RE: **Addendum No. 1/City of Mission Event Center**
Request for Proposal No.: 17-010-11-29

ADDENDUM 1

Date: 11-16-2016
Project: Mission Event Center
Project No.: 2016-01

SHEET NO
E1.2

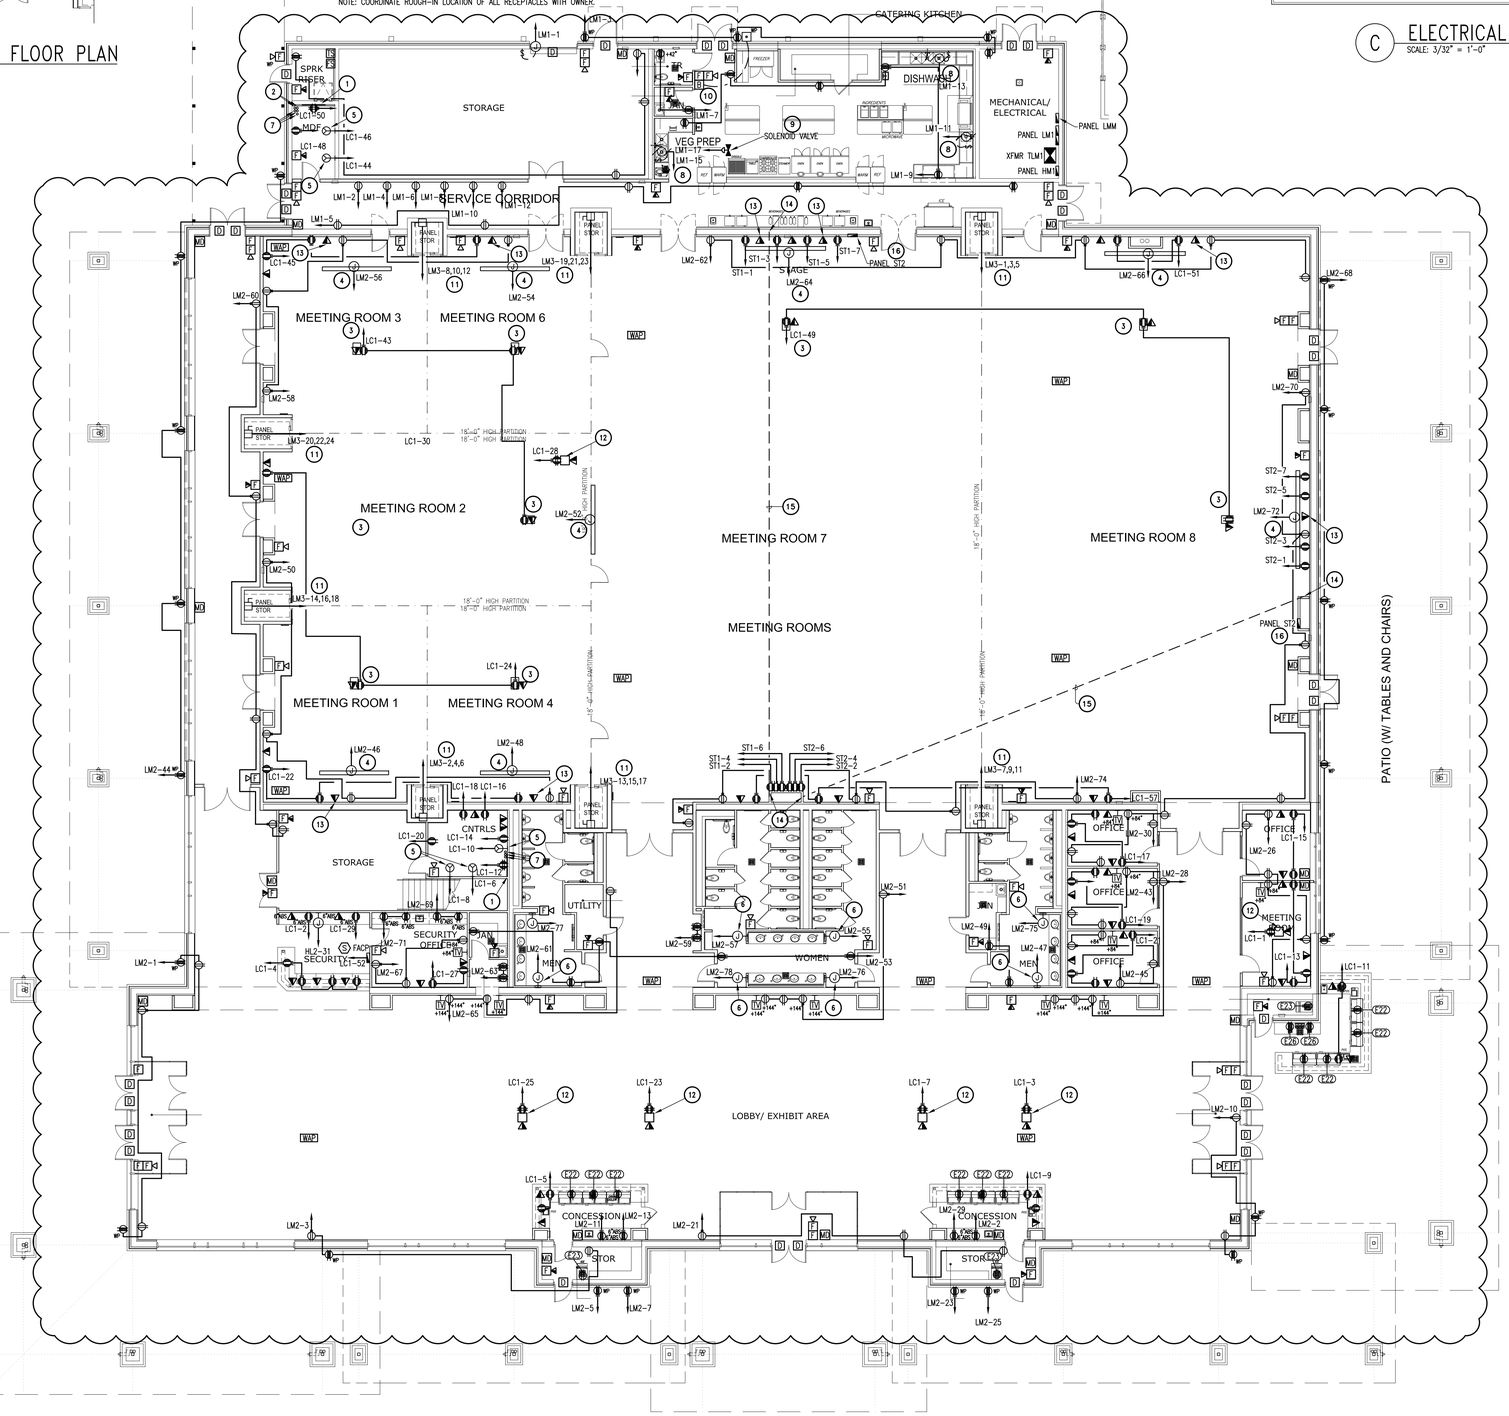
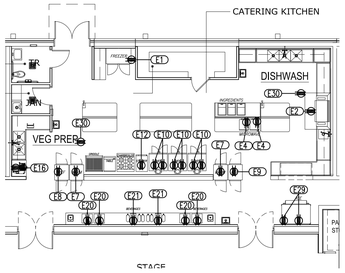
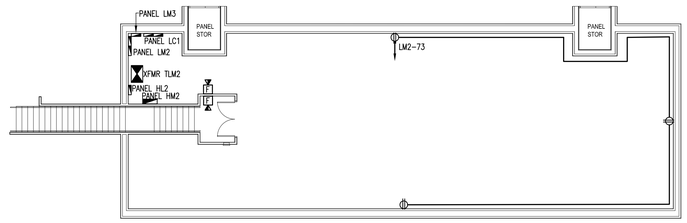
6. *Modification:* There will be four (4) new floor receptacles, recessed and flush, added to the lobby in specified locations. Cover color to be bronze. Refer to Revised **Sheet E1.2** and Architectural **Sheet A-6** attached for locations of new floor receptacles.

Item 4 Sheet E1.2, Electrical Power Plan, added floor boxes at Lobby/Exhibit Area, removed speakers, and added conduits/panels. Refer to attached drawing.

SHEET NO
E2.1

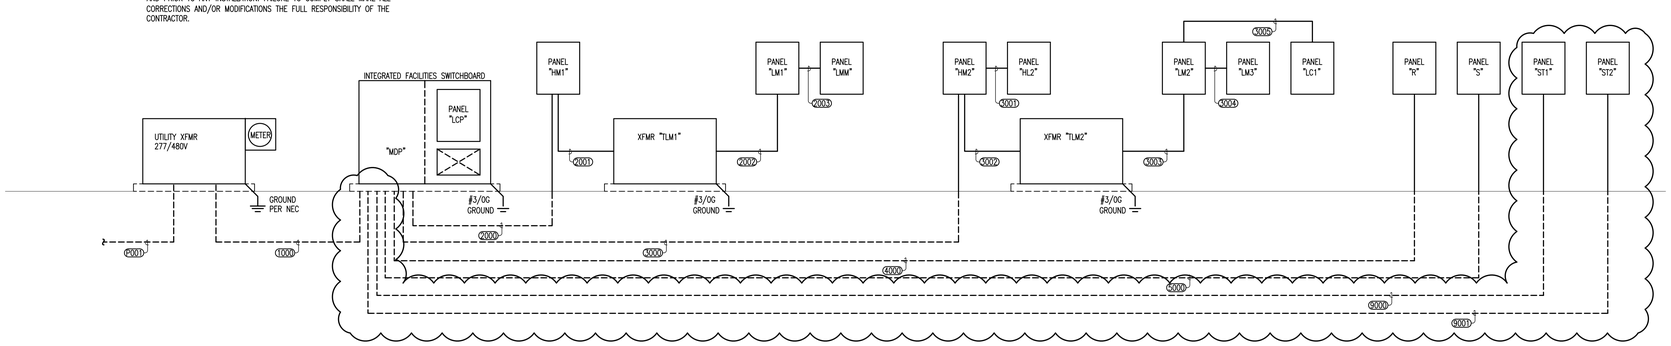
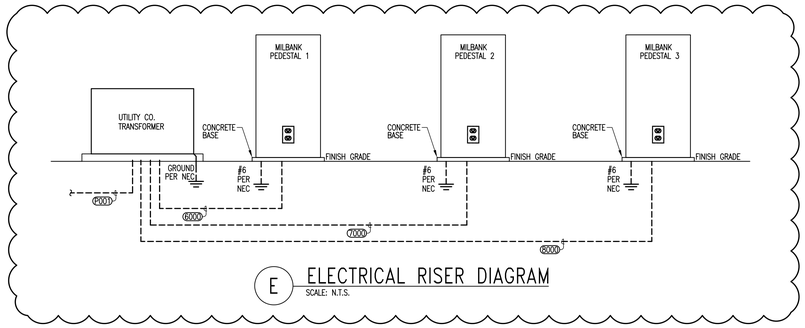
Item 5 Sheet E2.1, Electrical Riser Diagram & Schedules, added riser diagram for electrical service pedestals and stage panels. Revised transformer and feeder/branch circuit schedule. Refer to attached drawing.
